E4418B-22A

S E R V I C E N O T E

E4418B EPM Power Meter

Power Meter Display Shrink

Figure 1

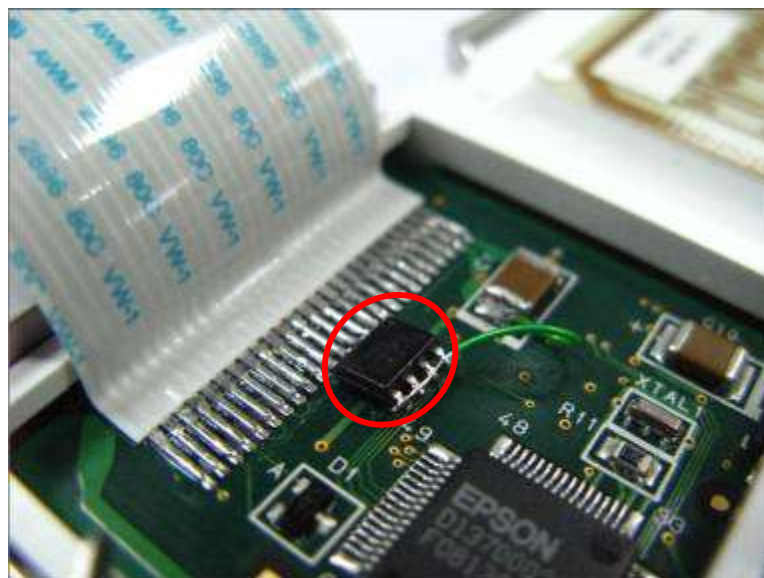
To resolve this problem, replace the front panel assembly with a good one. A good front panel has additional Transient Voltage Suppress (TVS) diode soldered on its PCA **OR** additional ribbon cable with Damping Resistors attached to it. The photos for good front panel assembly are shown below. Additional of TVS diode **OR** Damping Resistors will prevent the display shrink from happening.
